From: [Nicholas Davies](#)
To: [Urban Design Comments](#); [Plan Commission Comments](#); moliveira@plazastreetpartners.com; [Field, Derek](#)
Subject: 3915 Lien Rd (86523 / 86494) site access
Date: Sunday, February 16, 2025 3:25:51 PM
Attachments: [image.png](#)
[image.png](#)

On your agendas this week, you have *yet another* drive-thru coffee shop proposed for the East Wash / BRT A corridor. This site is 0.2 miles (7 mins on foot) from the nearest station at Mendota St.

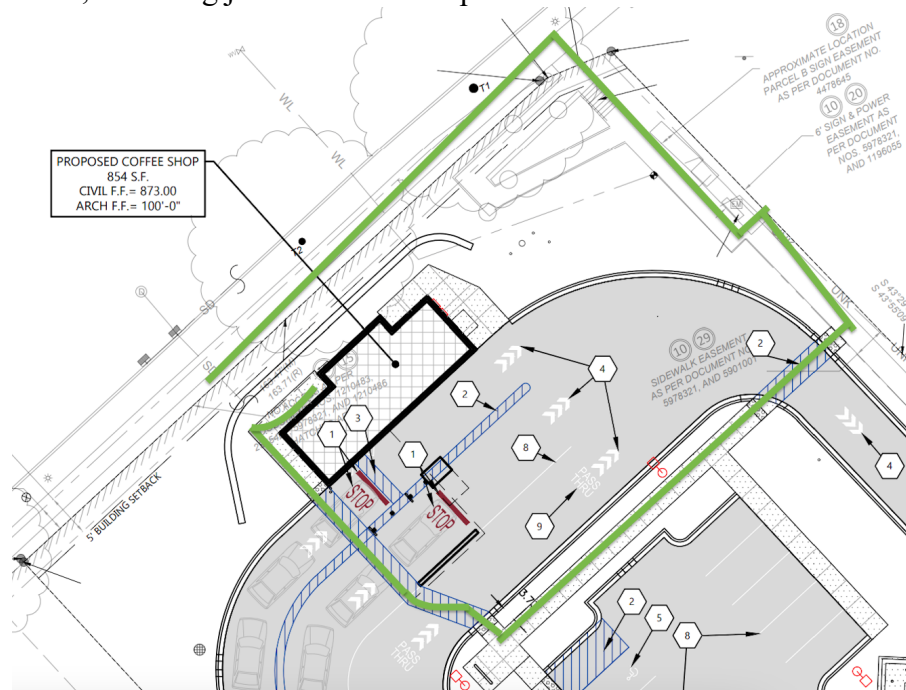
These plans show a sidewalk connection from E Wash to the coffee shop, but it's very circuitous, and involves crossing the vehicular traffic twice. I've highlighted it in green here:

There is a much more direct approach available, which I expect will become a well-worn desire line, at least for able-bodied customers, which I've shown in purple.

In *these* plans, it's also very unclear which door--if any--is intended for public entry or service. These plans appear to be missing the "walk-up window" and gathering area mentioned in the TDM worksheet.

Because of this door confusion, I disagree with the UDC memo's assertion that the TOD entrance orientation requirement is met--at least in the plans provided to UDC.
